September 29, 2022

RE: Champion Xpress Car Wash 5307 4th Street NW Revised Grading and Drainage Plan Engineer's Stamp Date: 08/12/22 Hydrology File: F14D036A

Based upon the information provided in your submittal received 08/15/2022, the Revised Grading & Drainage Plan is approved for Building Permit, SO-19 Permit, and for action by the DRB on Platting. Please attach a copy of this approved plan in the construction sets for Building Permit processing along with a copy of this letter.

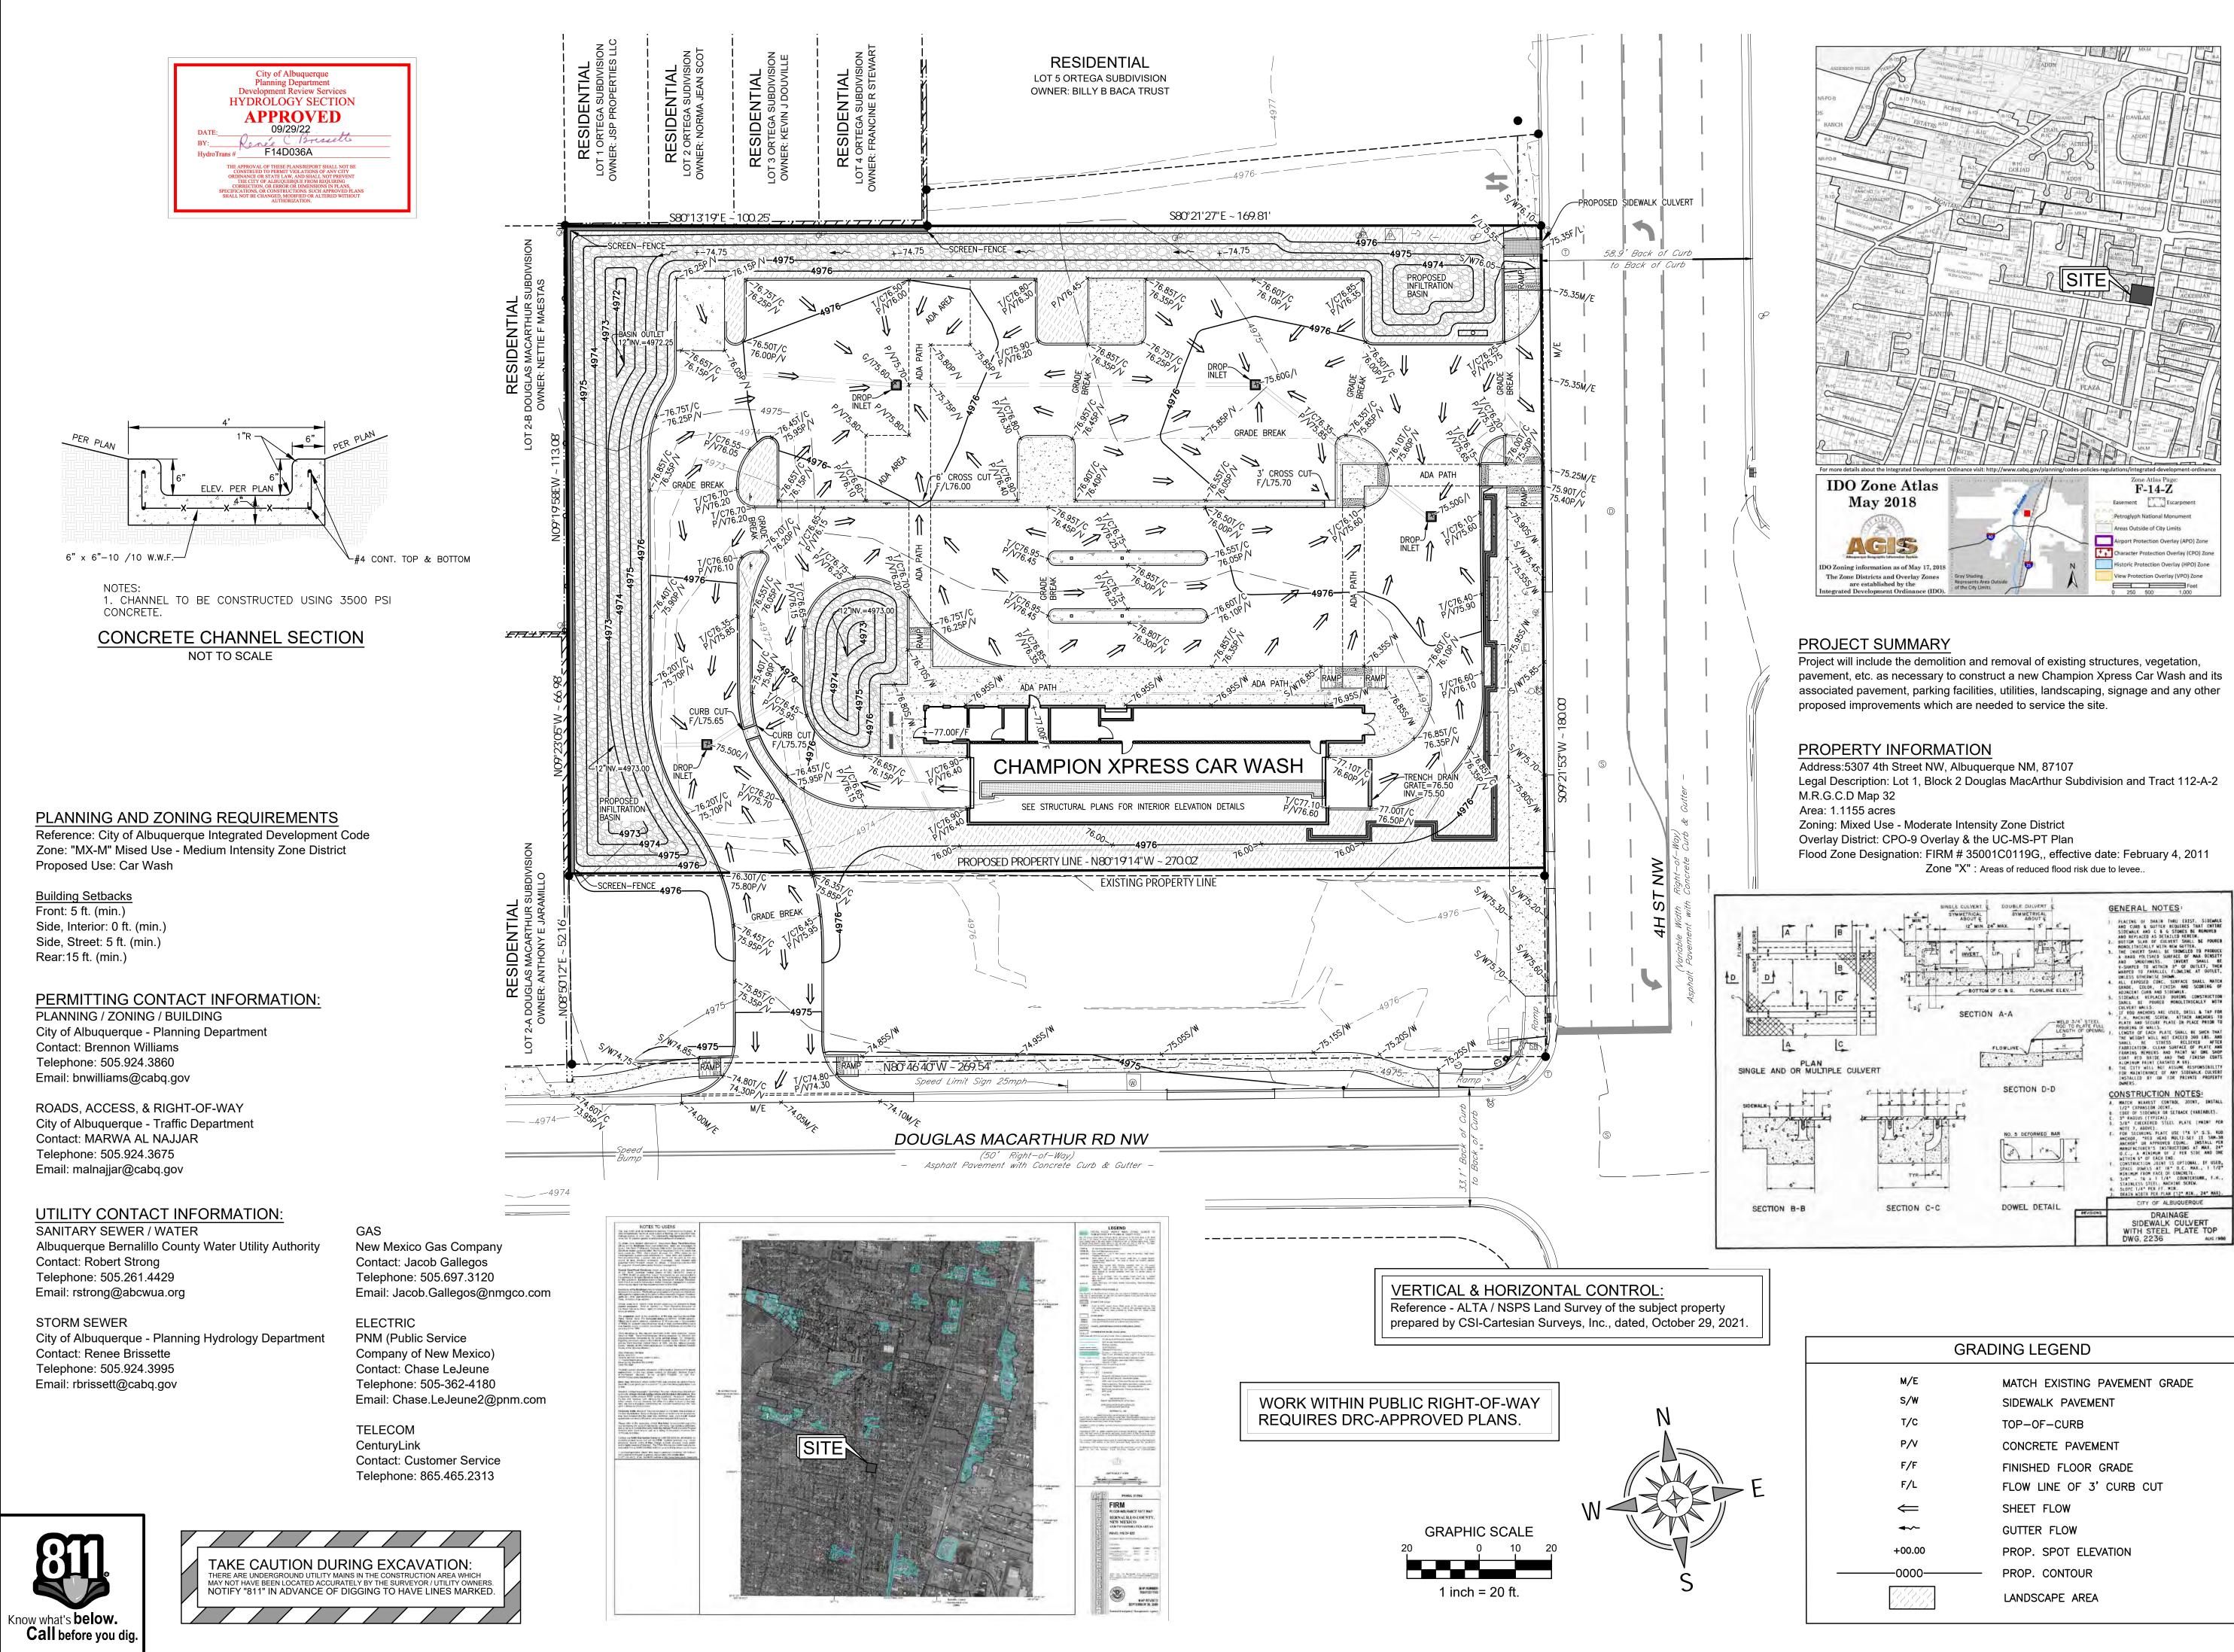
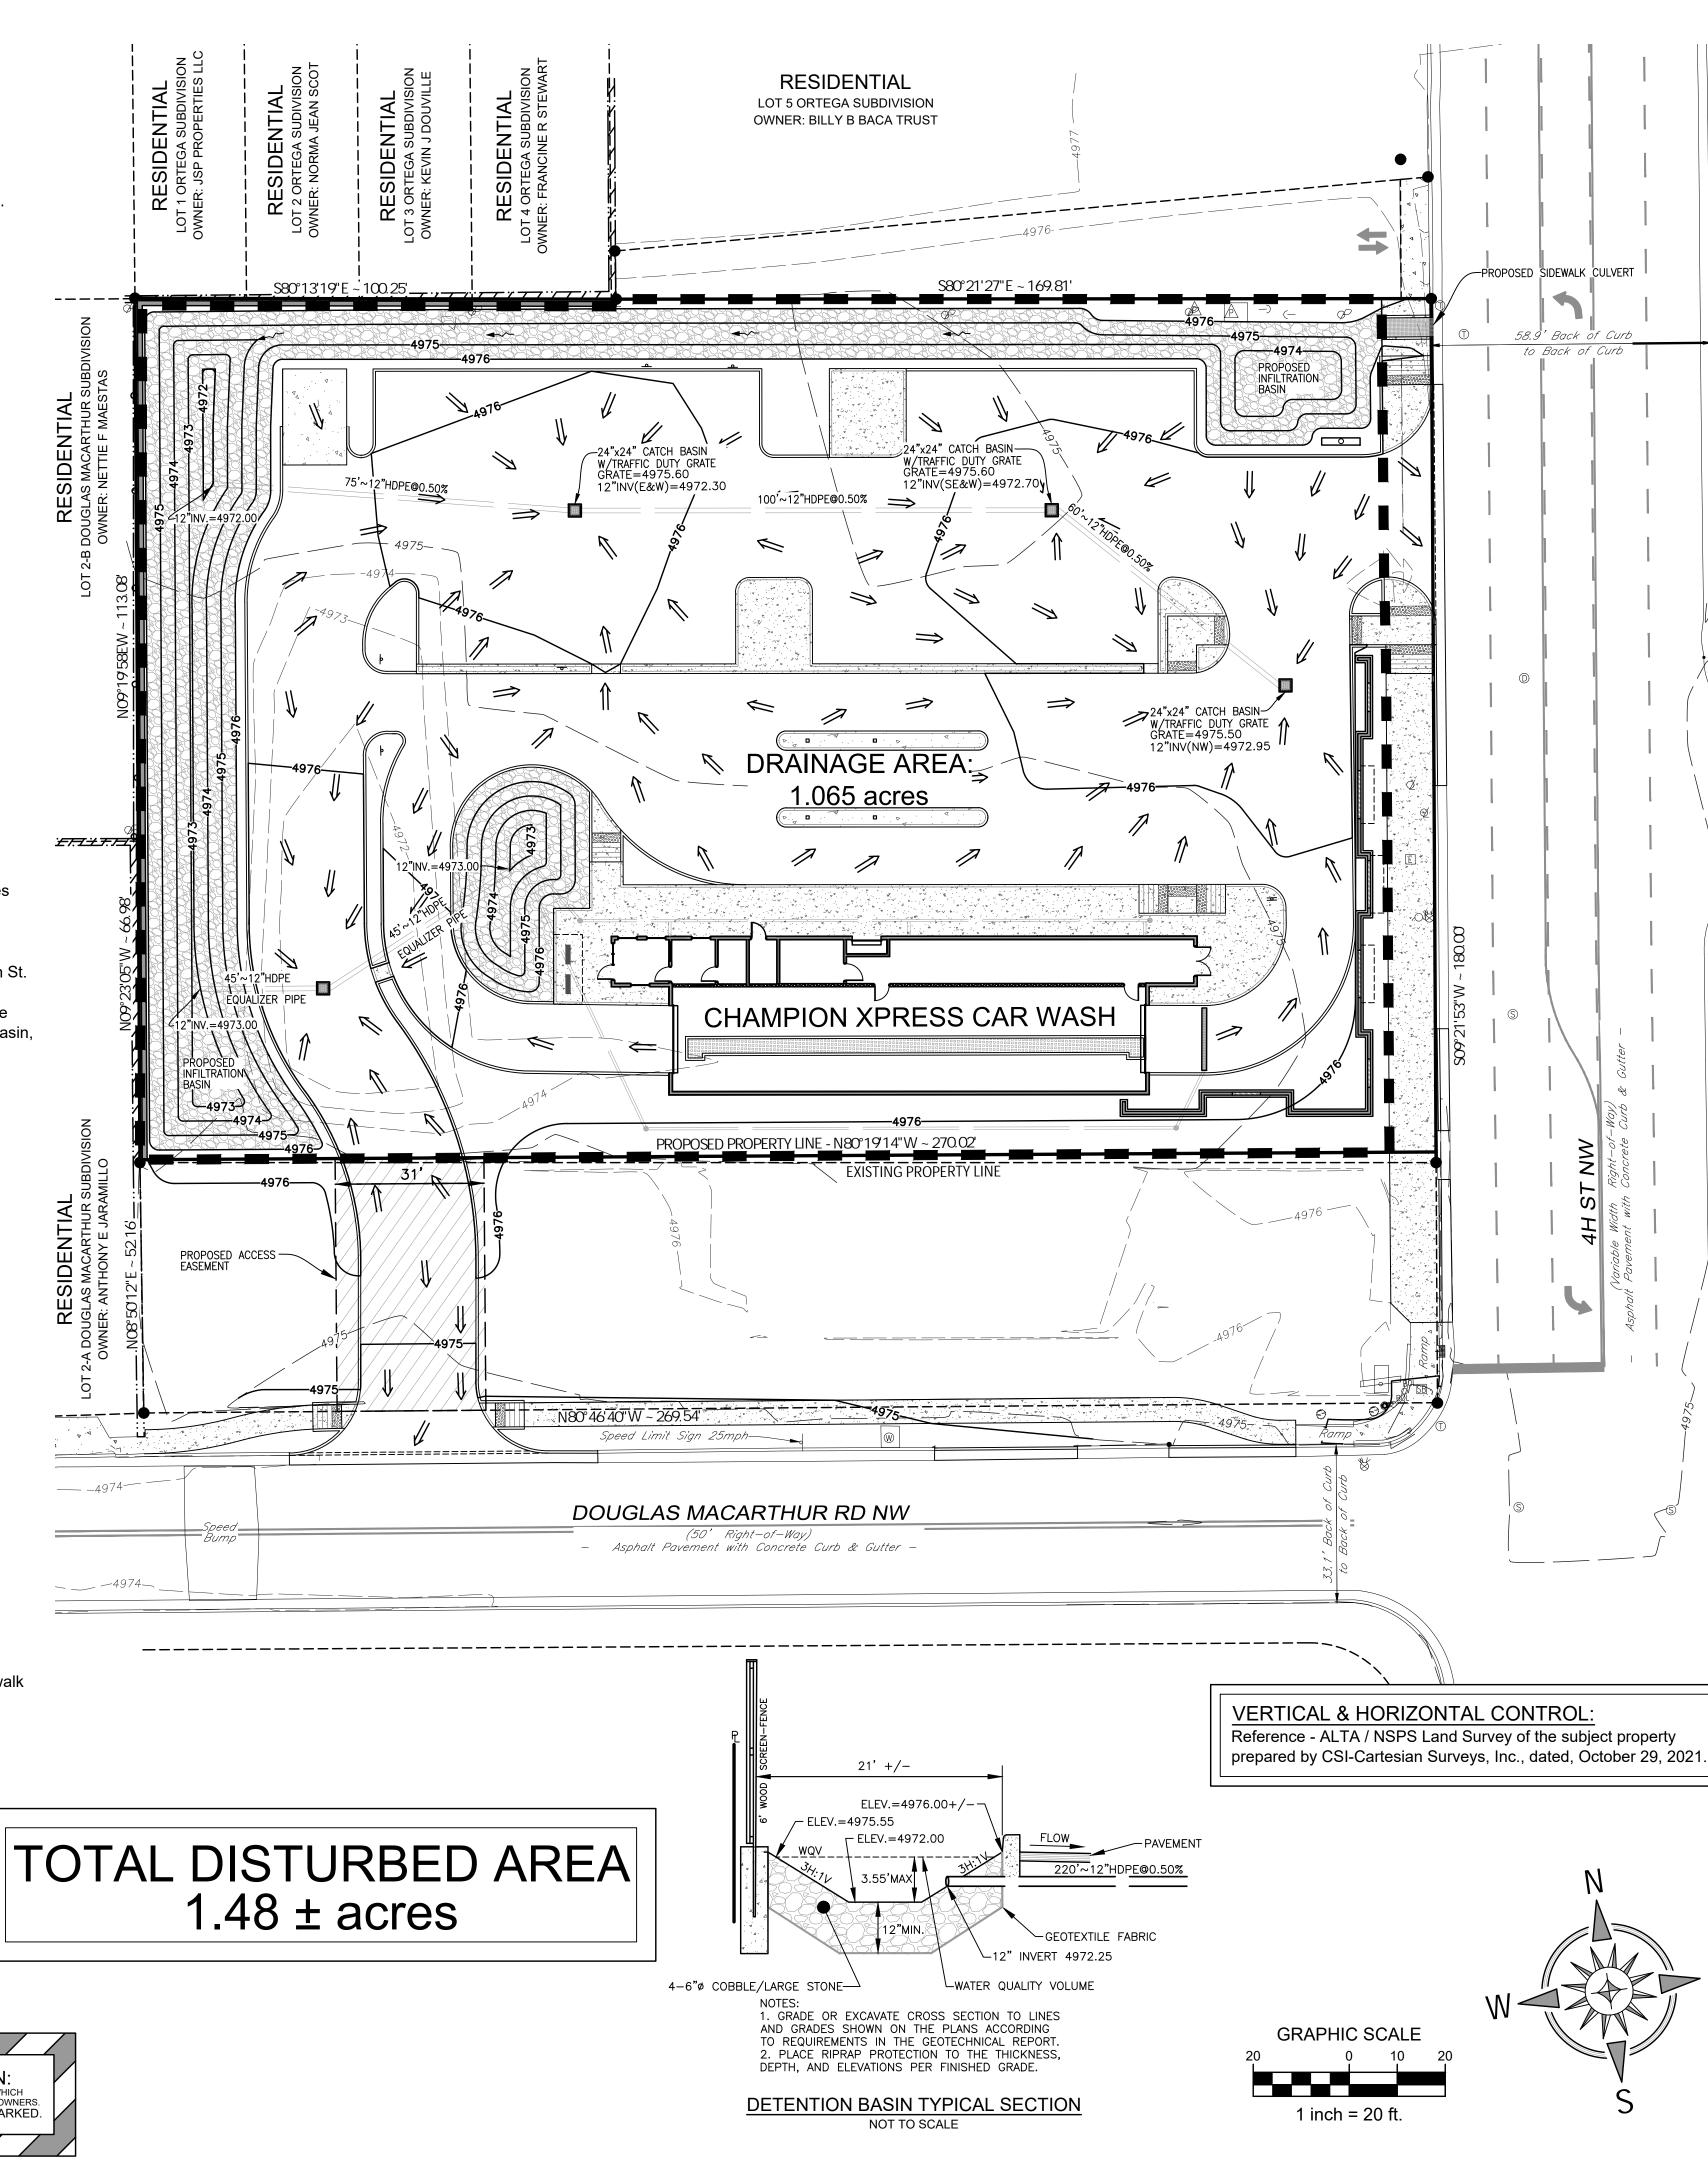
- Albuquerque 1. Engineer's Certification, per the DPM Part 6-14 (F): *Engineer's Certification Checklist For Non-Subdivision* is required.
- ^{NM 87103}
 Please provide the Drainage Covenant with Exhibit A for the stormwater quality ponds per Article 6-15(C) of the DPM prior to Permanent Release of Occupancy. Please submit the original copies along with the \$25.00 recording fee check made payable to Bernalillo County to Carrie Compton (<u>cacompton@cabq.gov</u>) on the 4th floor of Plaza de Sol.
